**METROPOLITAN GOVERNMENT OF NASHVILLE AND DAVIDSON COUNTY**

**STAFF RECOMMENDATION**  
**301 Broadway and 105 3<sup>rd</sup> Avenue South**  
**December 19, 2012**

**Application:** New construction-rooftop addition, Signage, Alterations  
**District:** Broadway Historic Preservation Zoning Overlay  
**Council District:** 19  
**Map and Parcel Number:** 09306402700, 09306402800  
**Applicant:** John Barnett, B3 Studio  
**Project Lead:** Robin Zeigler, robin.zeigler@nashville.gov

east elevation (along 3rd ave.)

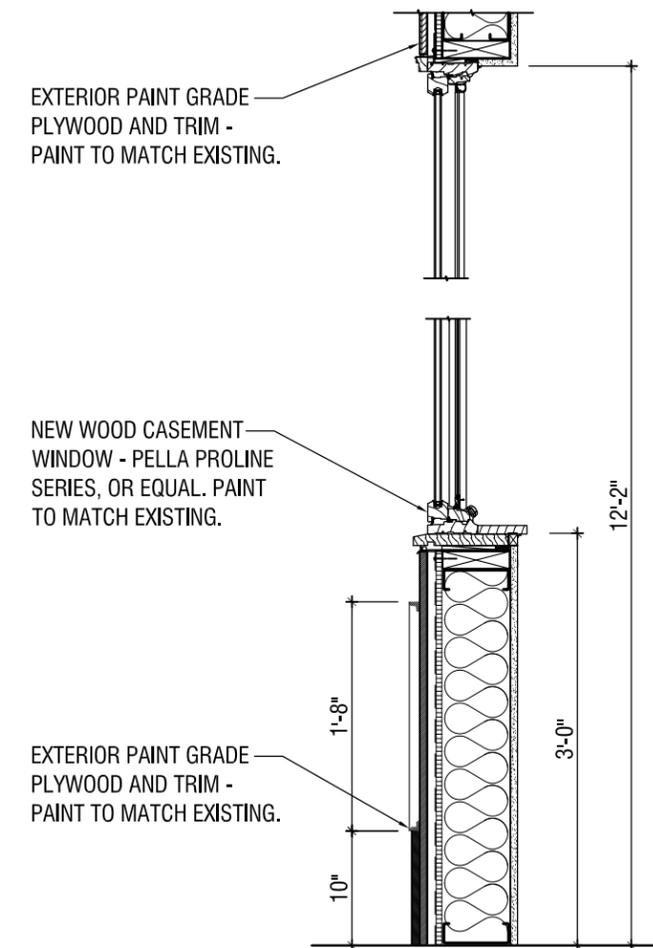
The windows and doors of this façade have been removed and there are no known photographs of its original appearance. The pilasters are original and shall be retained. The close rhythm of pilasters is not seen on Broadway but is prevalent on Second Avenue, so those storefronts were used to guide an appropriate design for this building's age and style, as required by the guidelines. The existing transoms will be retained and new clear glass installed.

Between each pilaster there will be a three foot (3') tall wood paneled bulkhead with double windows above.

The primary entrances will be double full-light and wood glass doors, which keeps the proportion of glass to door comparable to the proportion of display windows.

roof plan

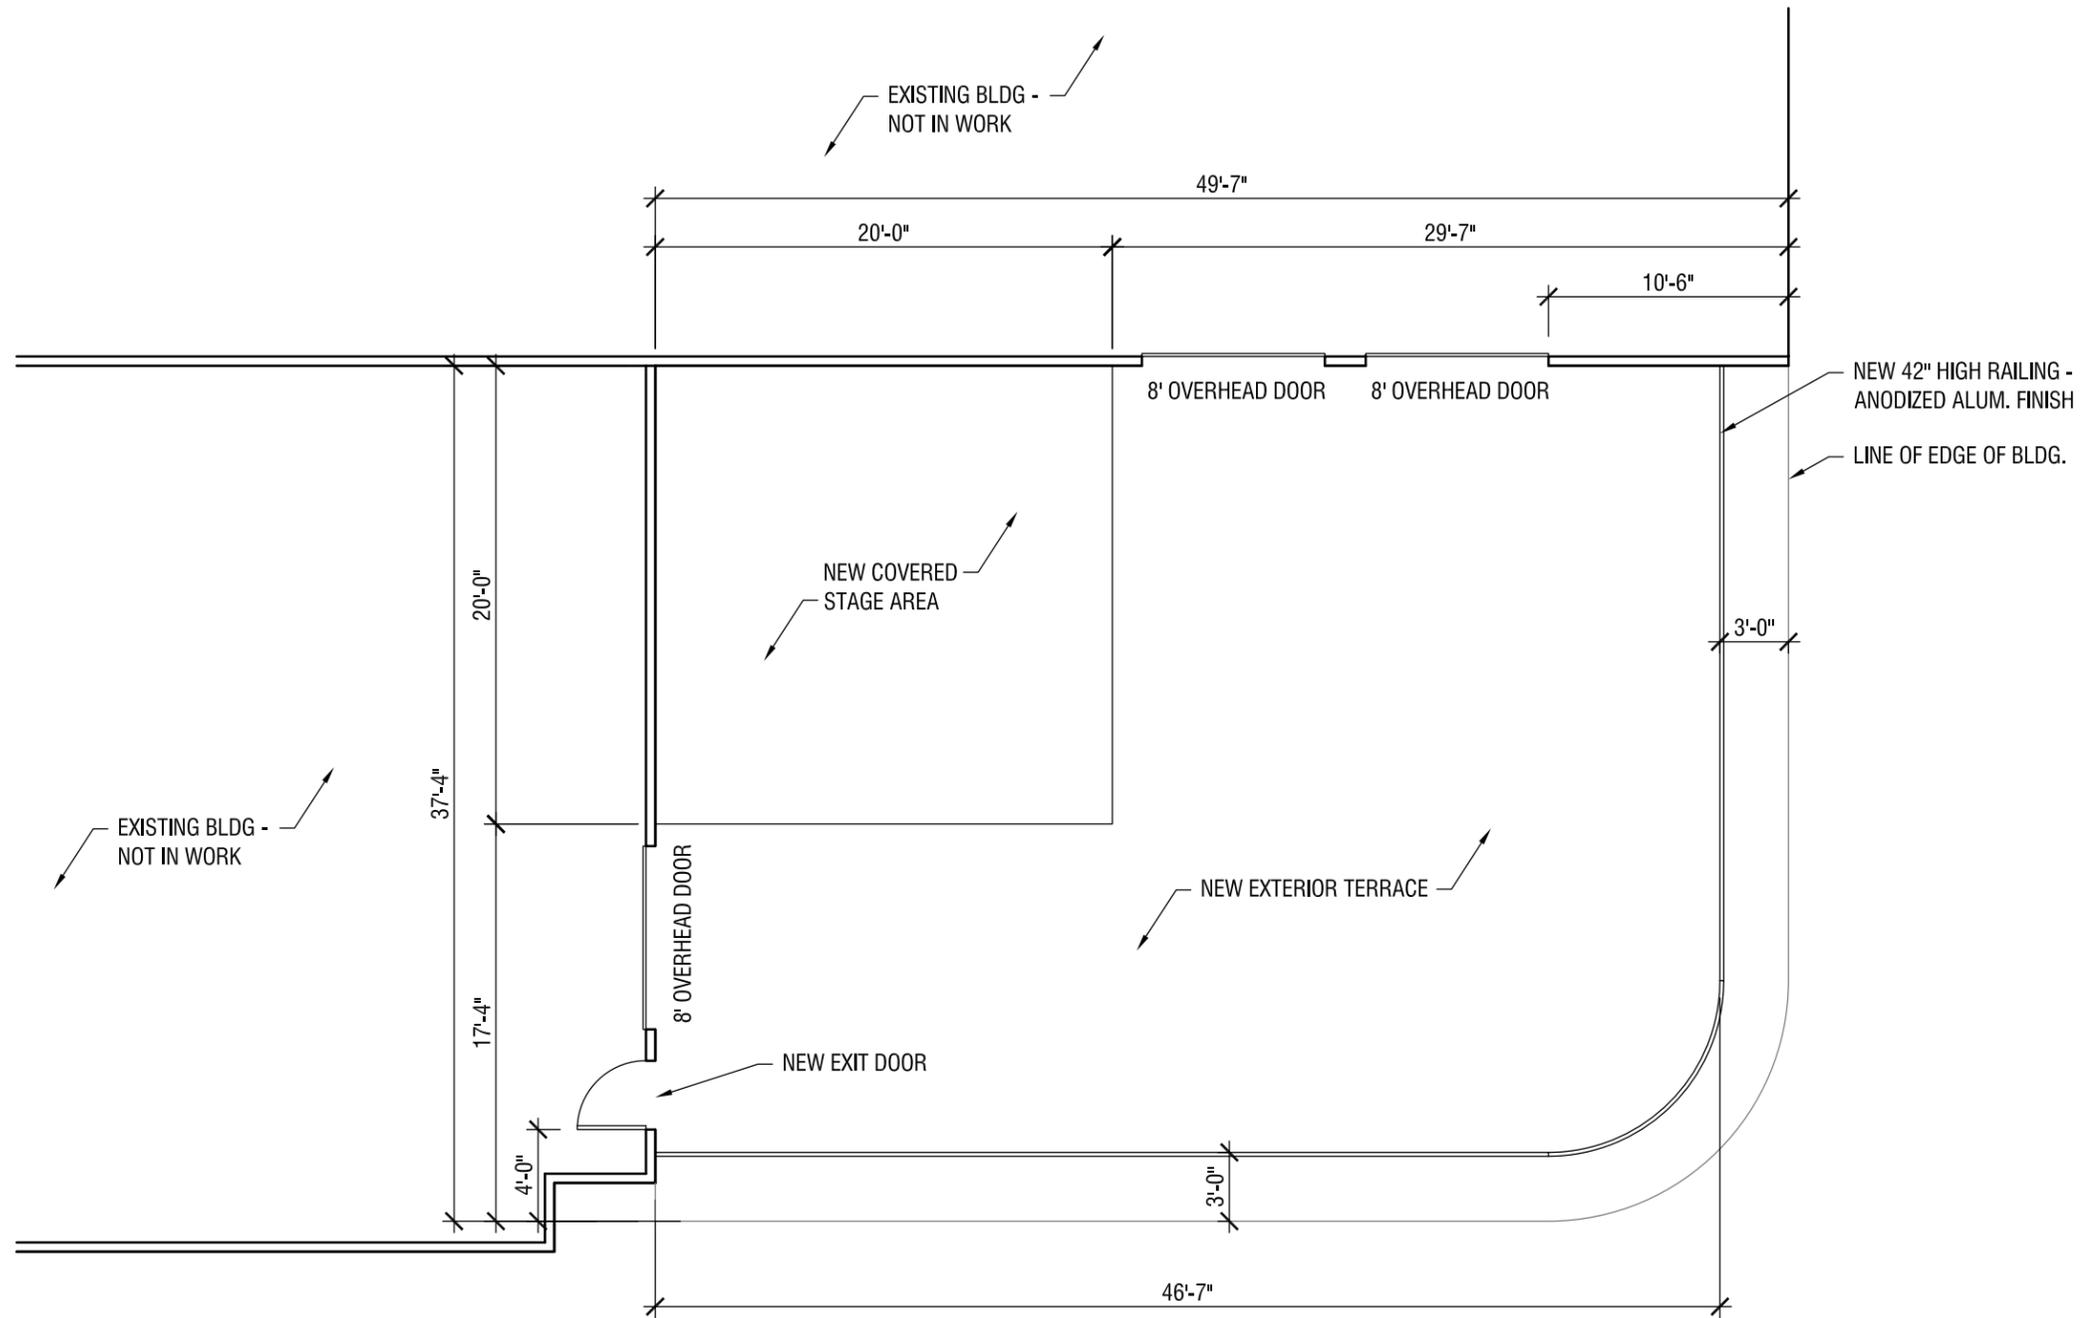
The guidelines require that rooftop additions be set back from side elevations by twenty feet (20') and the proposed structure is setback seventeen feet and four inches (17' 4"). The addition should sit back from the front elevation by thirty feet (30') and the proposed structure is twenty-nine feet and seven inches (29' 7"). Because the structure portion of the addition does not have walls and therefore should have a minimal visual impact, staff finds the setbacks for the covered stage area to be appropriate. Staff recommends that the structure not have permanent or temporary sides added without a permit, as has been required of other similar projects and not have anything attached to the exterior of the structure.

The railing is proposed to sit off the front wall of the existing building three feet (3'). Although the railing is part of the addition and should sit back the required amount, the Commission has made allowances for railings in the past since they can be minimally visible. On two recent cases, the Commission has required for one of them the railing sit back eight feet (8') and the other nine feet (9') because the building had a low parapet wall. Staff recommends that the railing be setback at least eight feet (8') and that it never has anything attached to it such as lighting or signage, as has been required of other similar projects.

In addition to the covered structure and the railing, the addition includes the construction of three garage doors and one pedestrian door into the side walls of the two historic buildings which flank 301 Broadway. As these doors will be highly visible and detract from the historic character of the buildings and the district, staff recommends that all doors be moved to meet the setback requirements for rooftop additions.

1. The sign connections not interfere will decorative details;
2. Additional information about the face of the sign be submitted;
3. All doors to the addition be within the required setback area;
4. The railing never have anything attached to it, such as lighting or signage;
5. The railing be set back a minimum of eight feet (8’) from the front wall of the building;
6. The structure should not have permanent or temporary walls added without a permit; and
7. The structure not has anything attached to except for items attached beneath the covered portion such as lighting and speakers.
